Title: COMBINED STAGE 1&2 ROAD SAFETY AUDIT

Proposed Residential Development at St. Evin's Park,

Monasterevin, Co. Kildare.

Report reference: 2008R01

Drawing 2305-DOB-XX-SI-DR-C-0050 S2 P01, Access road

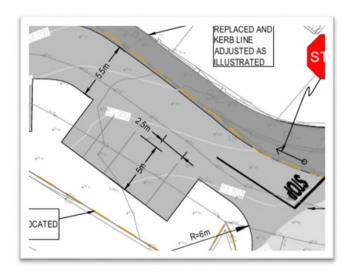
There may not be enough room for those using the perpendicular parking spaces to exit if the adjacent spaces are occupied given the relatively narrow (5.5m) carriageway access road. This could lead to material damage of parked vehicles.

It is recommended that that sufficient space be provided. This may require wider or longer parking spaces.

Paragraph No. in Safety Audit Report	Problem accepted (yes/no)	Recommended measure accepted (yes/no)	Alternative measures (describe)	Alternative measures accepted by Auditors (Yes/No)
3.1	Yes	No	Autotrack Analysis was carried out to ensure there is adequate space to reverse in and out of the proposed spaces	Yes
3.2	Yes	No	Highlighted in the attached report is the space designated for the most westerly unit.	Yes
3.3	Yes	Yes		
3.4	Yes	Yes

Drawing 2305-DOB-XX-SI-DR-C-0120 S2 P01, Kerb Height.

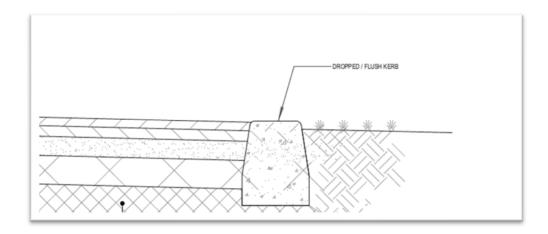
The access road kerb at the green area side is to be flush to allow surface water runoff. The absence of a kerb could lead to drivers parking partially on the carriageway and partially on the verge which could lead to loss of traction and control when exiting. The absence of a kerb could also lead to higher speeds as drivers perceive a wider road ahead.

It is recommended that a higher kerbs be provided with regular dips to be flush and allow surface water runoff.
